PACIFIC GAS AND ELECTRIC COMPANY

PGandE Letter No.: DCL-84-186

Re: Docket No. 50-275, OL-DPR-76
Docket No. 50-323
Diablo Canyon Units 1 and 2
Responses to SSER 22

SSER 22, Allegation #123

FIGURE 1

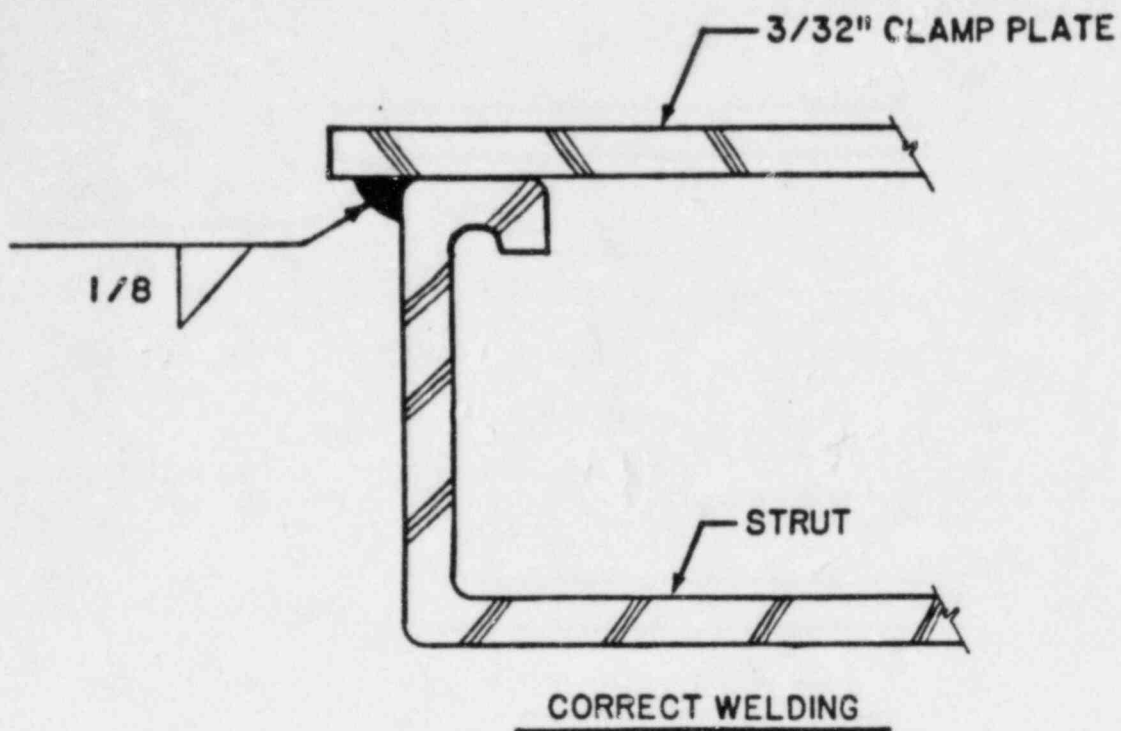
Welds of 1/8 inch were specified for use with the joint configuration shown in Figure 1 of Exhibit 2, attached. For this configuration, making a 1/8 inch weld to a 3/32 inch clamp plate is acceptable and is in conformance with the AWS D1.1 welding code.

This clamp modification was specified for only a few raceway cable tray supports in Unit 2. When Foley began construction of these modifications, they found that the existing clamps were not wide enough to place the specified weld as the joint configuration shown in Figure 2 of Exhibit 2, attached, actually existed. For the Figure 2 joint configuration, placement of a 1/8" weld on the end of the 3/32" clamp plate would have been inappropriate. However, in the course of the normal DCN review process, Foley initiated an Engineering Disposition Request, notifying Engineering of the

actual condition. Engineering then revised the design. The existing clamp plates were replaced with wider clamp plates, restoring the Figure 1 joint configuration. Proper welds were then made. Alternately, in a few cases, the clamp was replaced with a clip angle that bolted to both the tray and the strut, thus eliminating the need for welding.
